**RE: 1500 Candelaria NE**  
**Grading and Drainage Plan**  
**Engineer's Stamp Date: 06/08/2022**  
**Hydrology File: H15D007A**

Based upon the information provided in your submittal received 06/13/2022, the Grading and Drainage Plan is approved for Building Permit and SO-19 Permit. Please attach a copy of this approved plan in the construction sets for Building Permit processing along with a copy of this letter.

ENGINEER'S SEAL	<b>DAHL PLUMBING</b> <b>1500 CANDELARIA RD NE</b>	DRAWN BY DEM
	<b>GRADING AND DRAINAGE PLAN</b>	DATE 6-7-22
6/8/22	 <b>Rio Grande Engineering</b> P.O. BOX 53924 ALBUQUERQUE, NM 87199 (505) 321-9099	1500 CANDELARIA RD NE.DWG
DAVID SOULE P.E. #14522		SHEET # C1
		JOB #

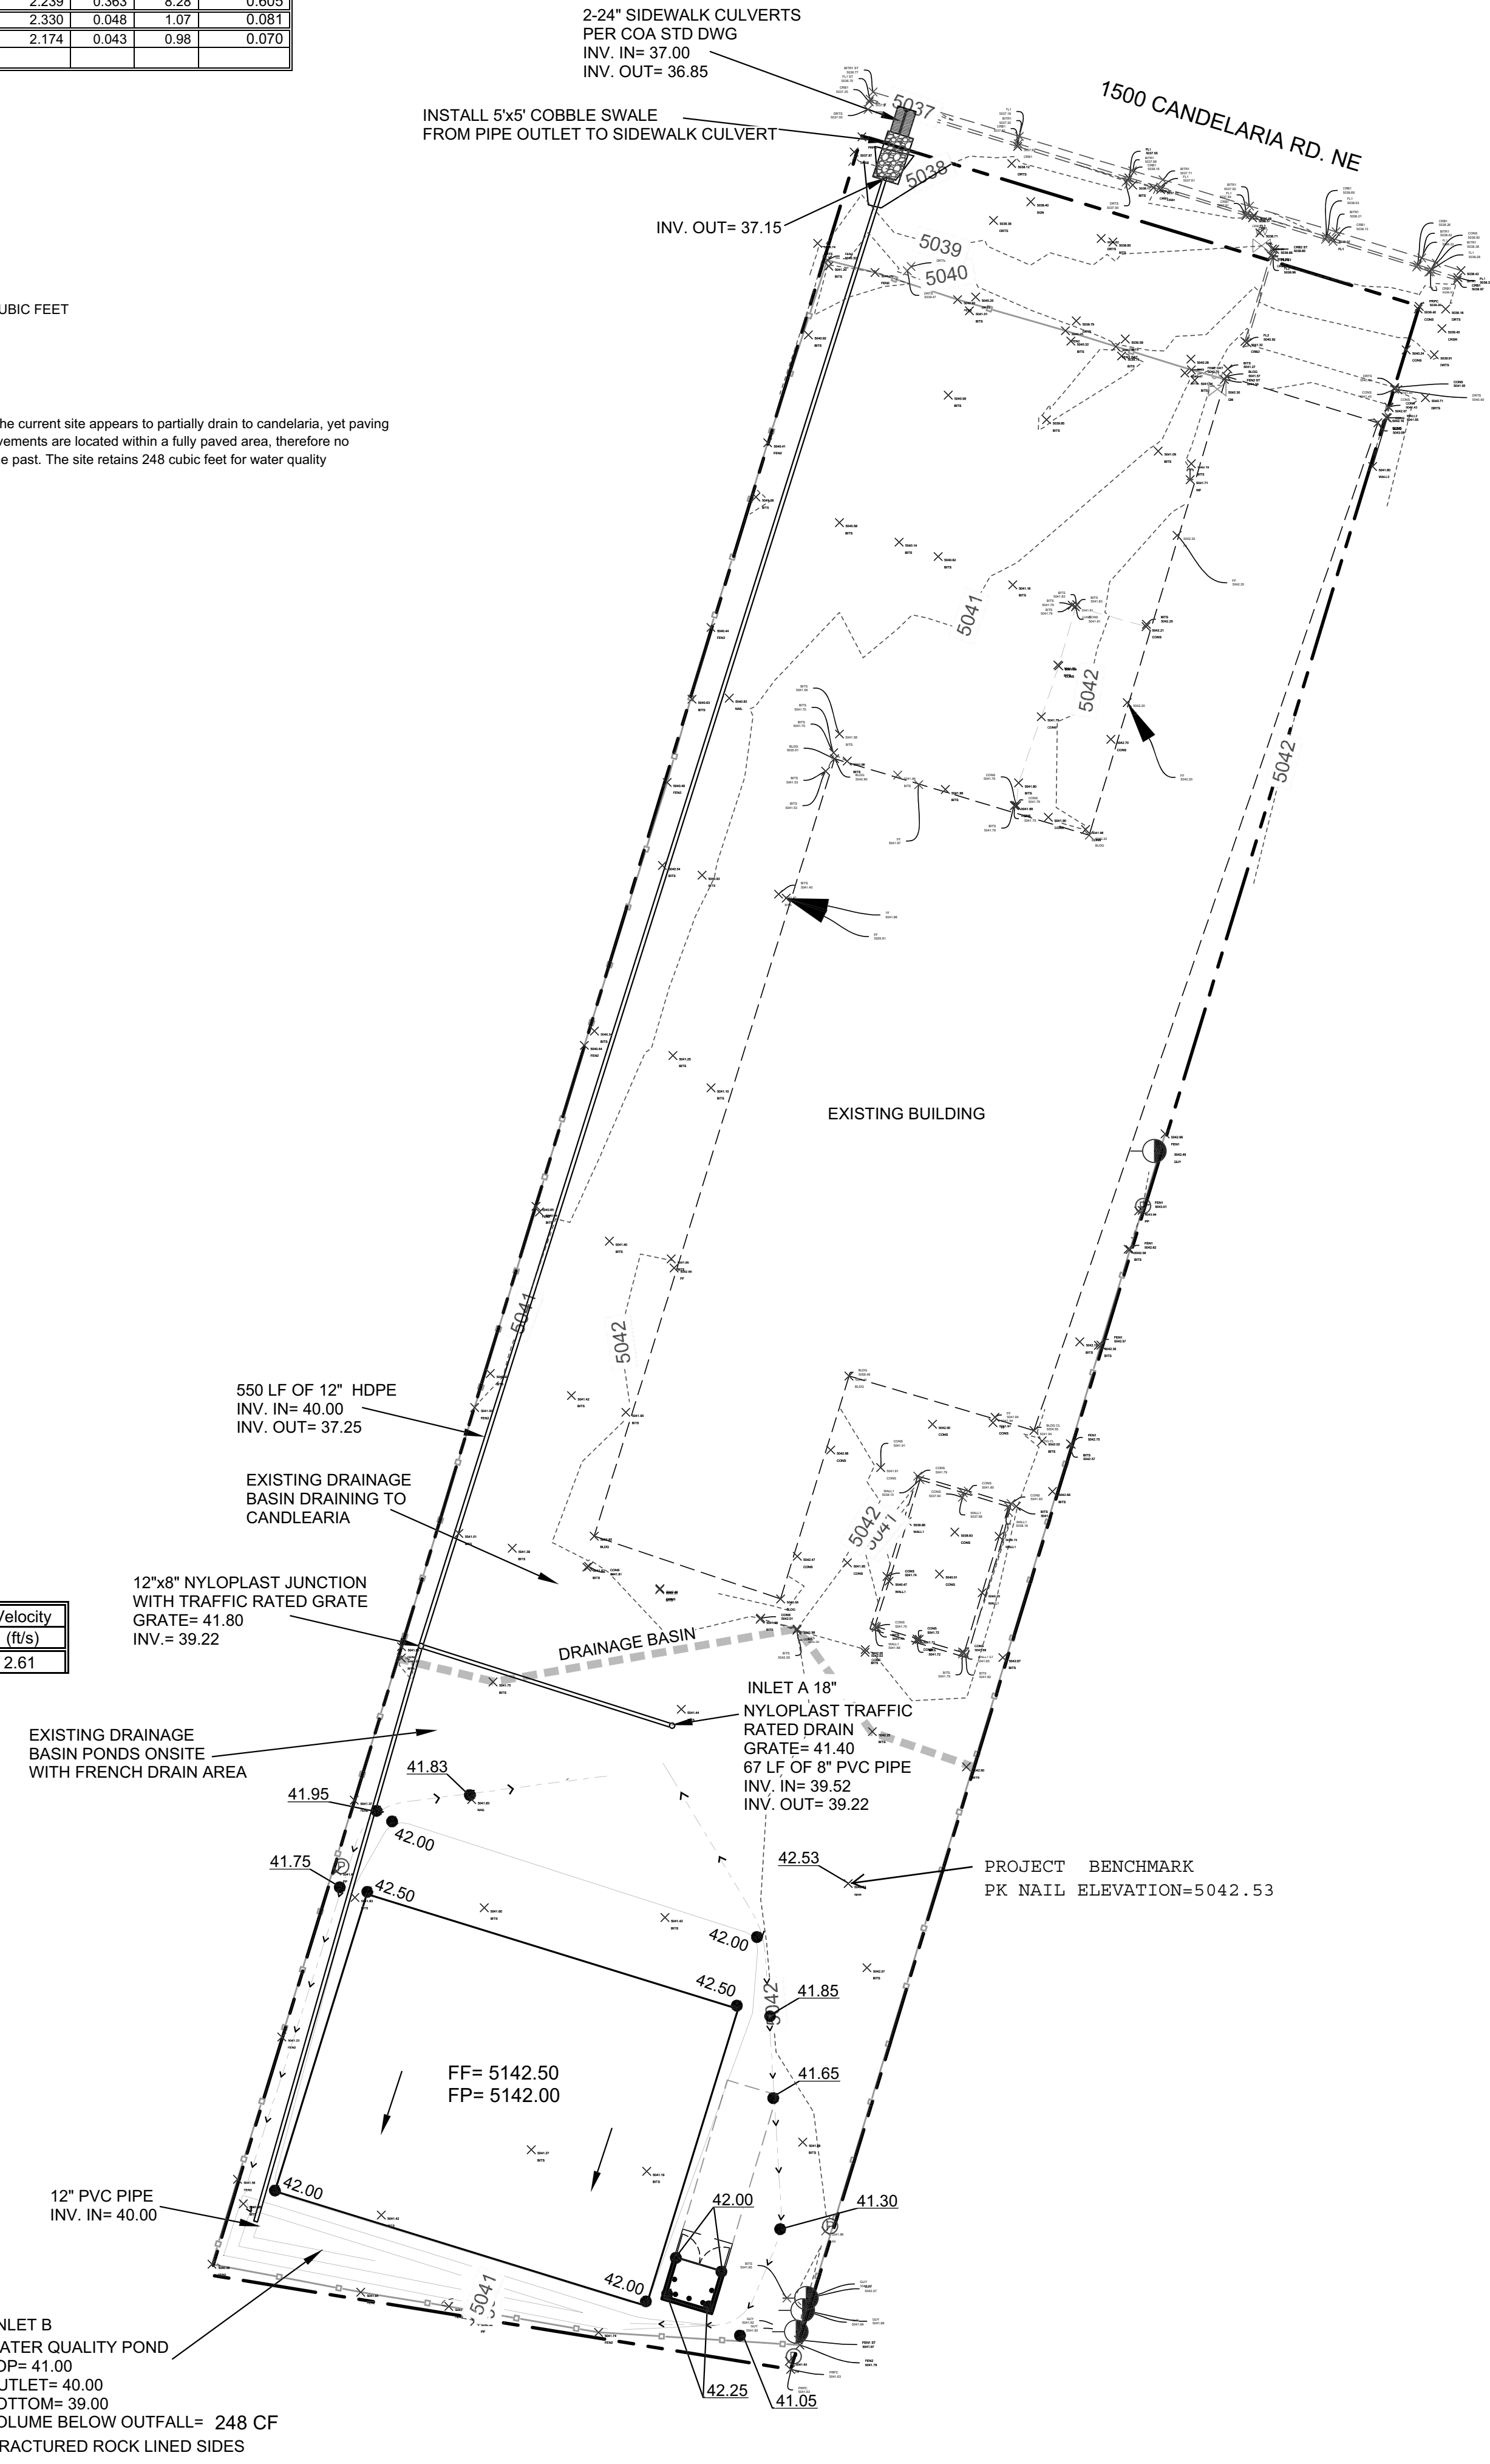
Please attach a copy of this approved plan in the construction sets for Building Permit processing along with a copy of this letter. Prior to approval in support of Permanent Release of Occupancy by Hydrology, Engineer Certification per the DPM checklist will be required.

Please provide Drainage Covenant for the stormwater quality ponds per Article 6-15(C) of the DPM prior to Permanent Release of Occupancy. Please submit an electronic file of the Covenant and Exhibit for completeness to Marion G. Velasquez at [mgvelasquez@cabq.gov](mailto:mgvelasquez@cabq.gov). Once the electronic file is approved for completeness, please submit the original copies along with the \$ 25.00 recording fee check made payable to Bernalillo County to Marion on the 4th floor of Plaza de Sol. Please note that Hydrology will need a pdf copy of the recorded Drainage Covenant prior to Hydrology's approval of Permanent Release of Occupancy.
